Proposal for changes to Regulation No. 46 (DEVICES FOR INDIRECT VISION)

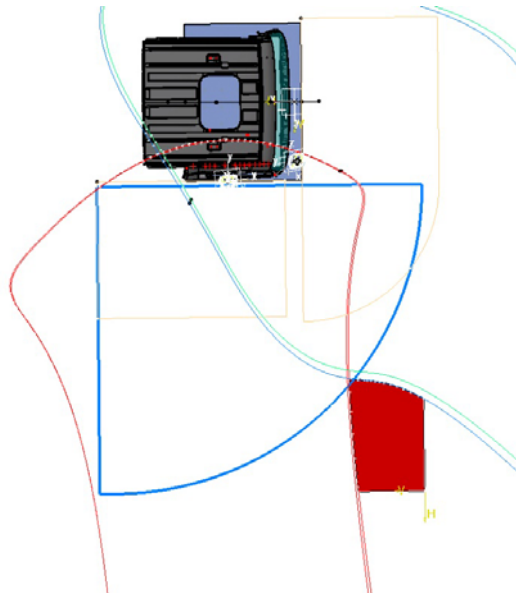
1. Step 1:
 - a. New FOV mandatory for N3
 - b. New FOV mandatory for N2 with high cabs (HOW TO DEFINE THEM?)
 - c. New FOV adapted to address
 - i. Interference with existing mirrors
 - ii. Capacity of new mirror to cover FOV (rounded angle could provide solution – see figure)
